# Access Compliance Report

## Public Rights-of-Way

Intersection ID: 31673	Main Street: NEW_DAY_CT	Cross Street: STARSHINE_DR	Location: NE
ADA ID: A1BA6D24A4F4	Ramp Type: PerpDiag	Initial Pass/Fail: Fail	Overall Compliance: No
Severity Score: 22.5			
Codes/Mitigation Info/Possible Solution		Field Measurements/Component Compliance

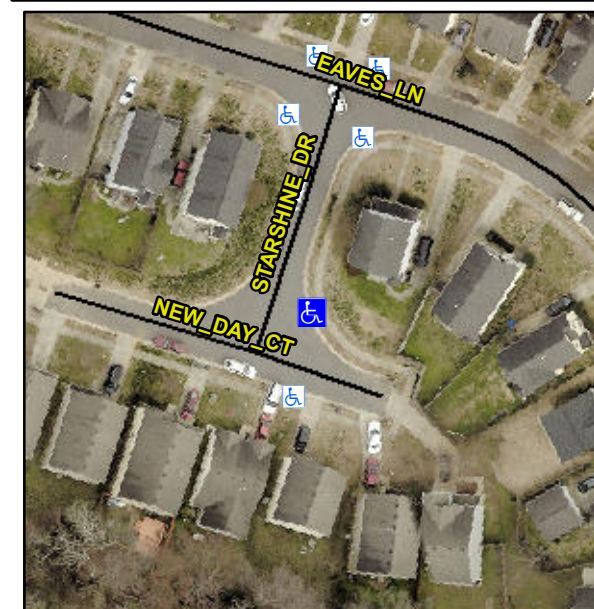
**Not Found, R304.5.1, R304.2.2, R304.5.3**

Compliance	Description	Data	Compliance	Description	Data
N/A	Ramp Length (in)	49.0	No	Ramp Slope (%)	8.6
No	Ramp Width (in)	45.0	No	Ramp XSlope (%)	4.1
N/A	Flare Type LT	N/A	N/A	Flare Type RT	N/A
N/A	Flare Slope LT (%)	N/A	N/A	Flare Slope RT (%)	N/A
N/A	Flare Traversable LT?	N/A	N/A	Flare Traversable RT?	N/A
N/A	Landing Length (in)	N/A	N/A	DWS Provided?	N/A
N/A	Landing Width (in)	N/A	N/A	DWS Contrast?	N/A
N/A	Landing Slope (%)	N/A	N/A	DWS Length (in)	N/A
N/A	Landing X Slope (%)	N/A	N/A	DWS Full Width?	N/A
N/A	Landing Curb? (Y/N)	N/A	N/A	DWS Offset (in)	N/A
N/A	Shared Landing?	N/A			
N/A	Gutter Ponding?	N/A	N/A	Gutter Slope (%)	N/A
N/A	Gutter Lip Ht (in)	N/A	N/A	Gutter X Slope (%)	N/A
N/A	Painted X Walk1?	No	N/A	Painted X Walk2?	No
	X Walk 1 Direction	To NW		X Walk 2 Direction	To SW
N/A	X Walk 1 Width (in)	N/A	N/A	X Walk 2 Width (in)	N/A
	X Walk 1 Slope (%)	0.5		X Walk 2 Slope (%)	0.7
	X Walk 1 X Slope (%)	0.7		X Walk 2 X Slope (%)	2.7

**Remove & Replace Curb Ramp With Two New Directional Ramps or Equivalent.**
